A d d e n d u m

Iowa Department of Transportation
Office of Contracts

B.O.	Proposal ID	Proposal Work Type	County	Project Number	Addendum
011	97-3761-006-A	BRIDGE REPLACEMENT - PPCB	WOODBURY	BRF-376-1(6)--38-97	21JUN011.A02

SHEET 2:

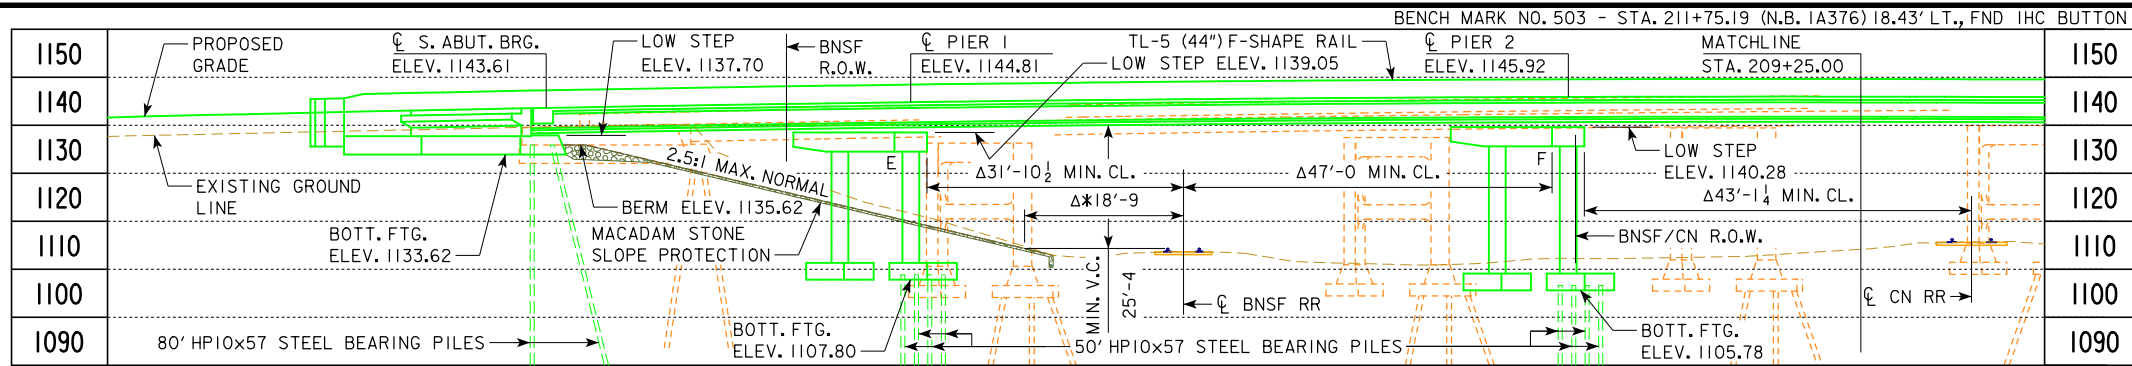
Change the following note of the GENERAL NOTES:

From: REMOVALS SHALL BE IN ACCORDANCE WITH SECTION 2401,
OF THE STANDARDSPECIFICATIONS.

To: REMOVALS SHALL BE IN ACCORDANCE WITH SECTION 2401,
OF THE STANDARDSPECIFICATIONS, EXCEPT THE REMOVAL
LIMIT FOR THE TWO EXISTING PIERS WITHIN THE CN R.O.W.
SHALL BE TAKEN AT THE TOP OF THE EXISTING PIER
FOOTINGS.

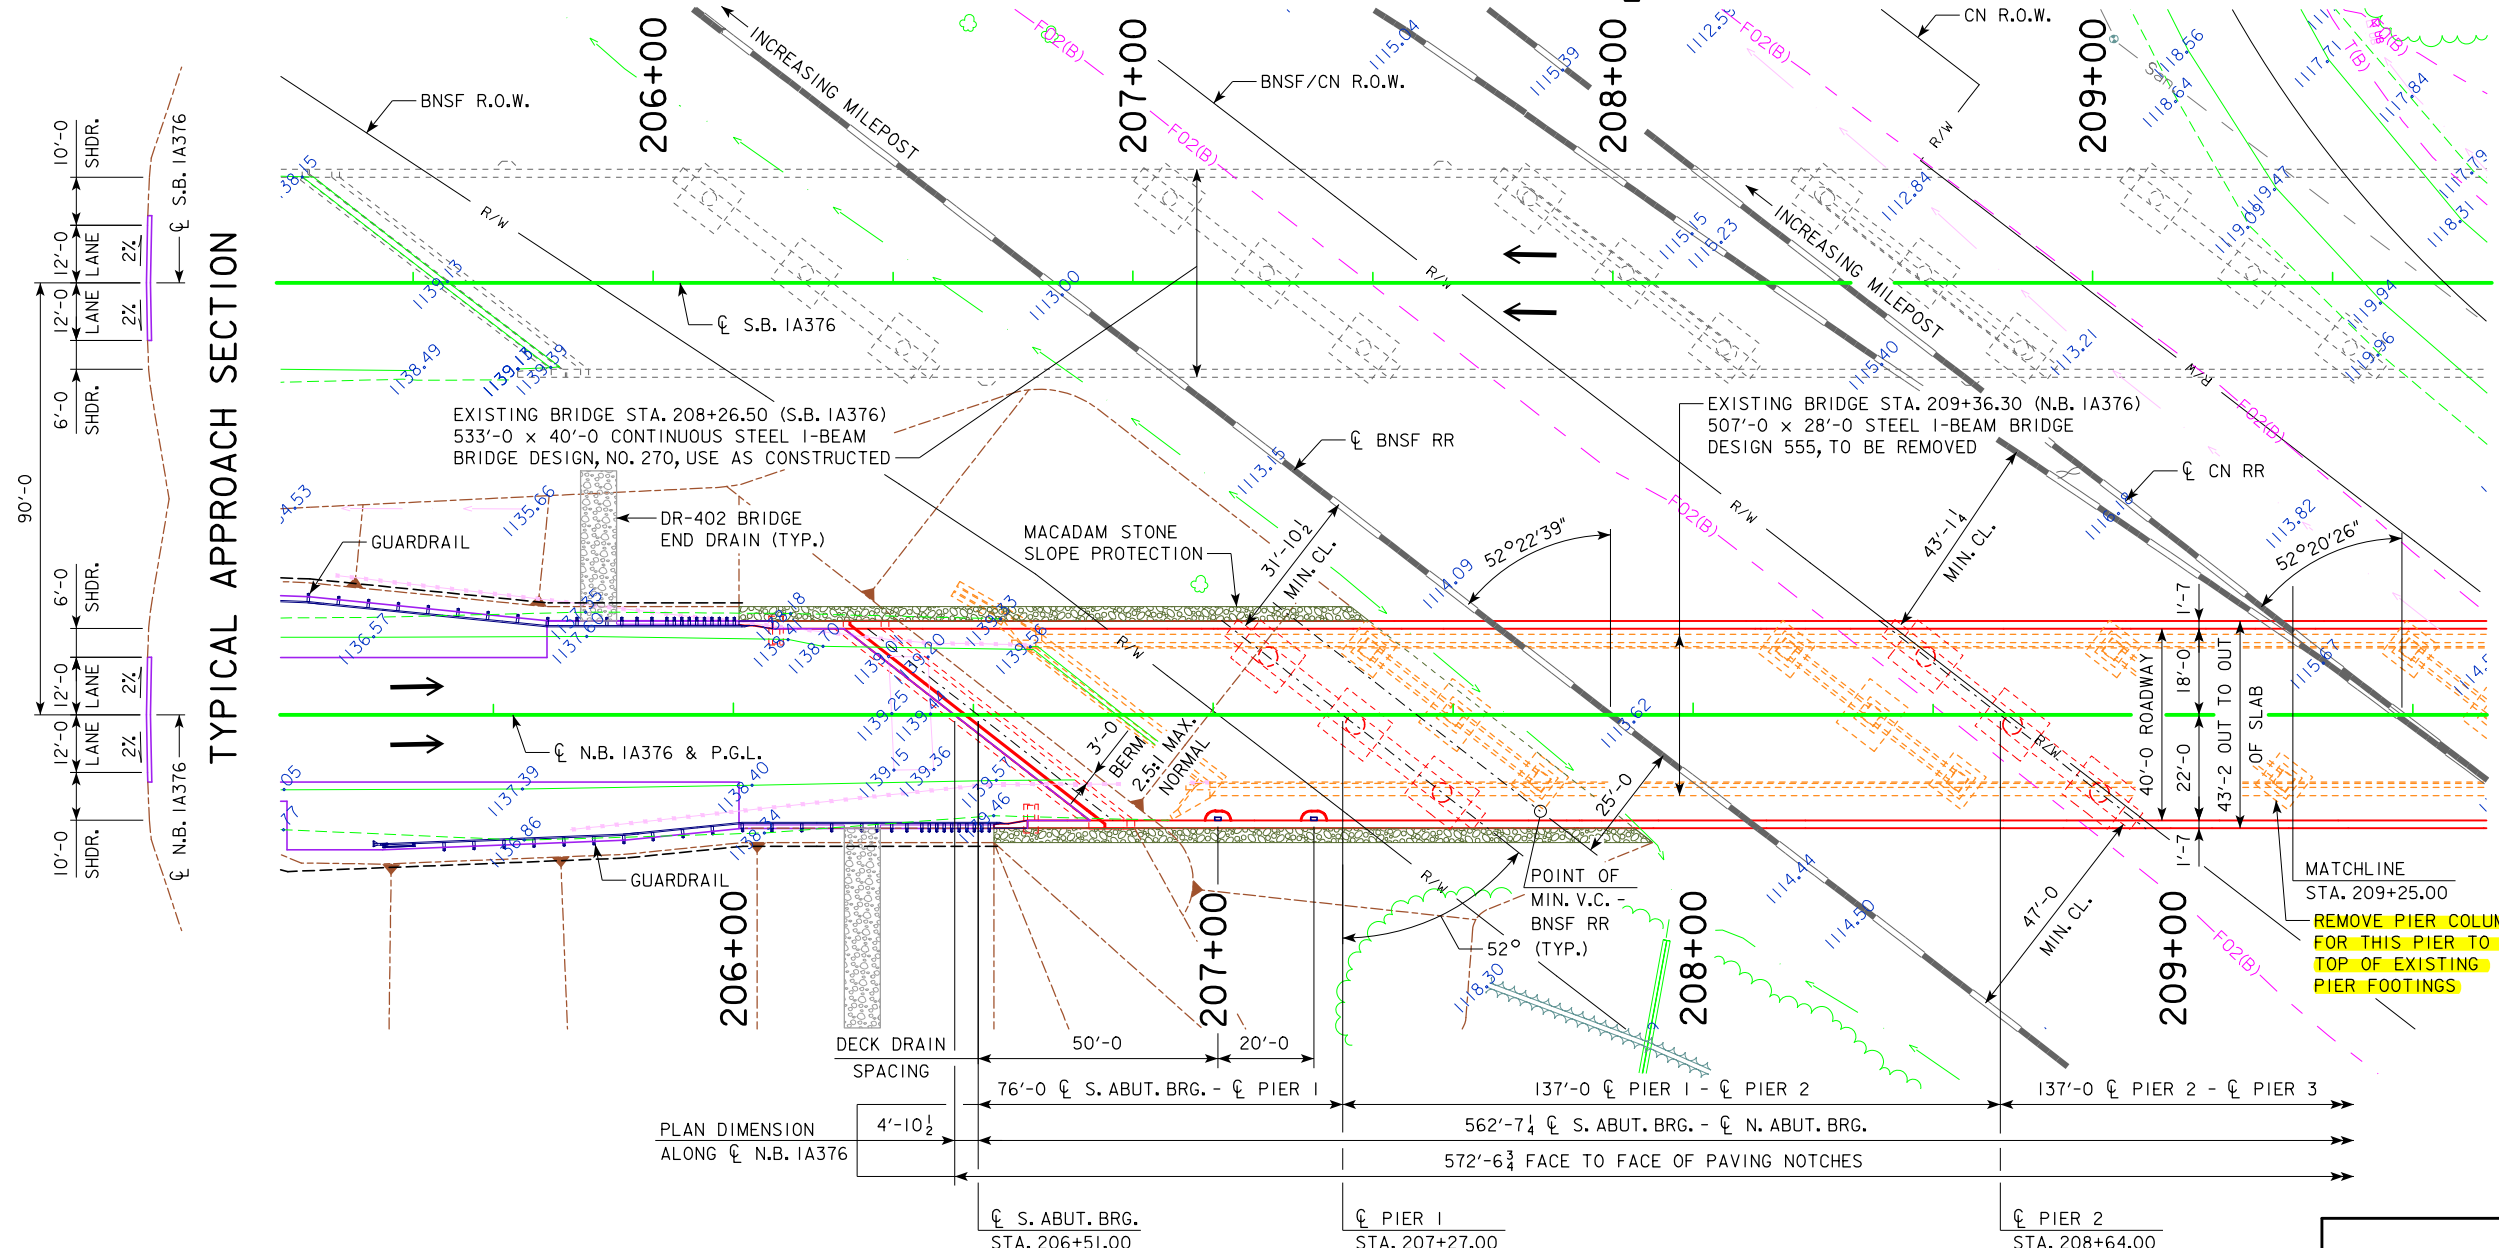
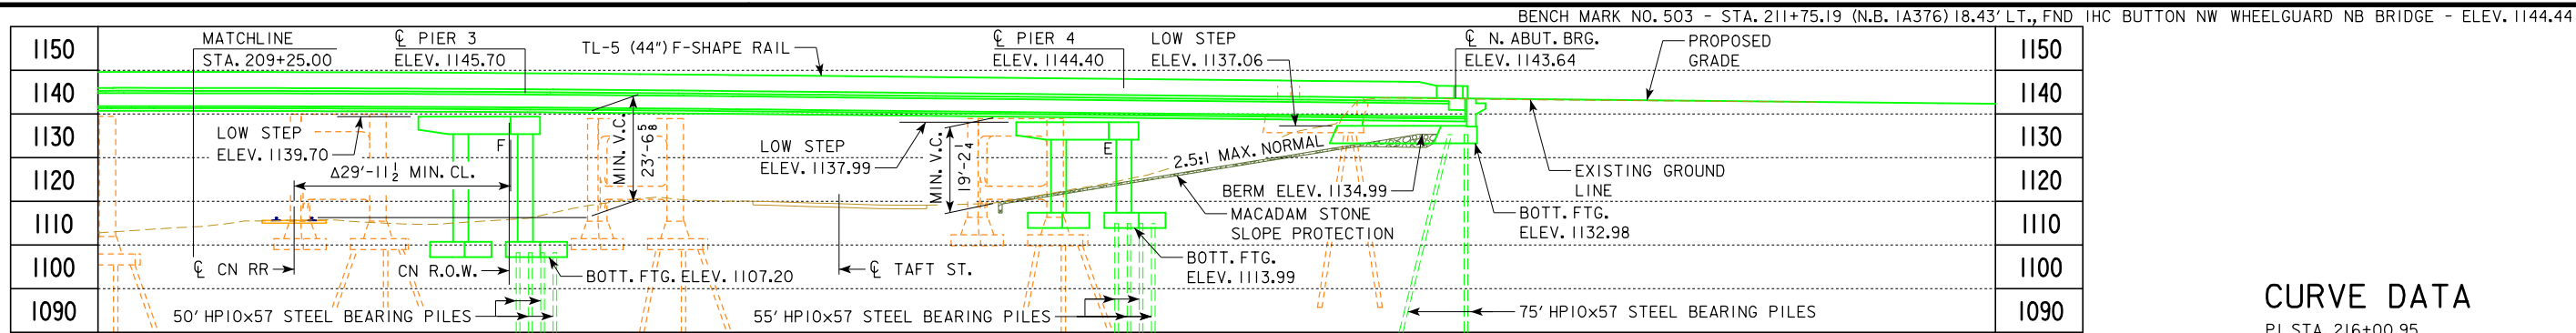
SHEETS 4 AND 5:

ADD NOTE:

REMOVE PIER COLUMNS FOR THIS PIER TO TOP OF EXISTING PIER
FOOTINGS
